## **ADDENDUM NO. 1**

**Project:** Wayne State College Willow Bowl Renovation

**Project No.:** L11045

**Date:** 21 May, 2012

DETAIL E1.1R1

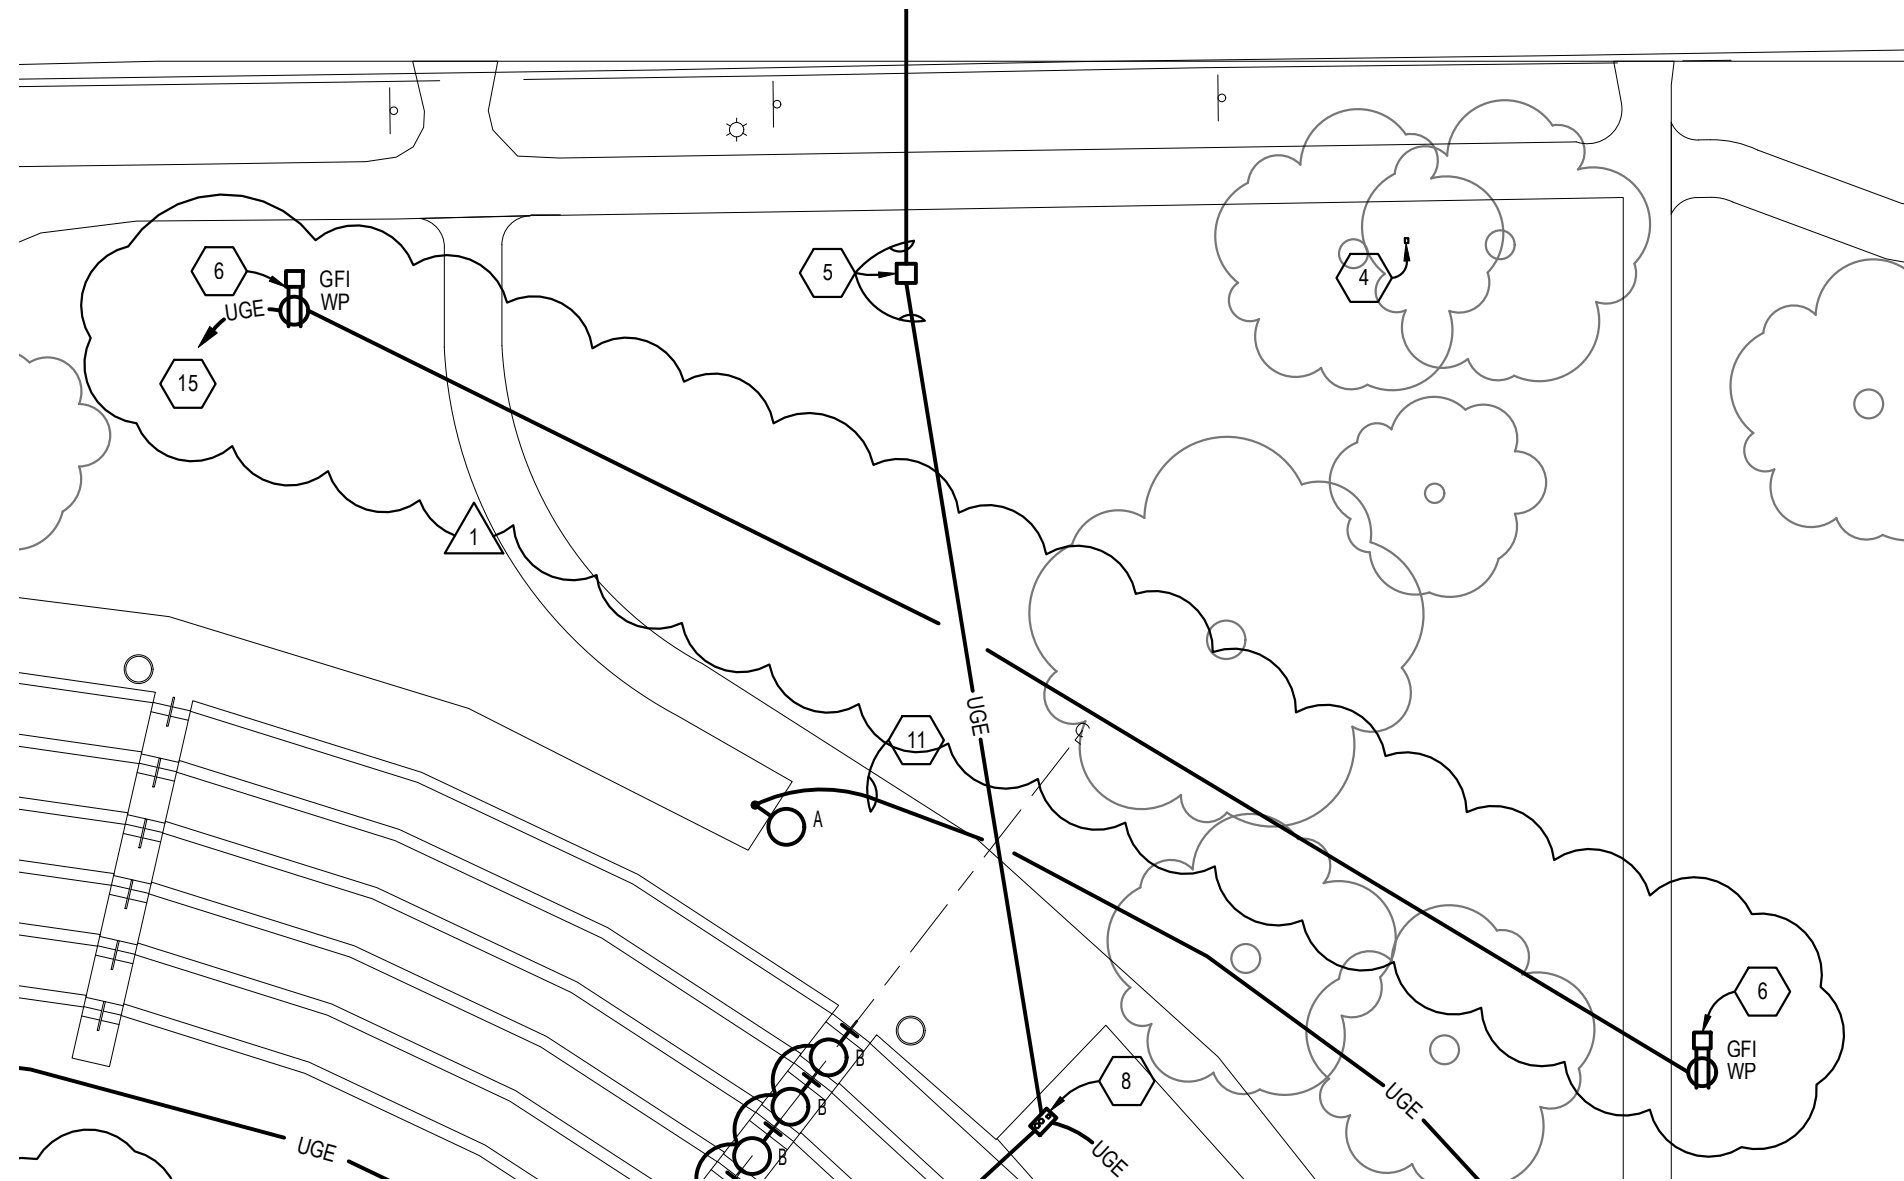
6. Reference Sheet E1.1
    - A. See attached supplemental details E1.1R1 and E1.1R2.
      1. Add receptacles and site lighting as delineated on attached details E1.1R1 and E1.1R2.
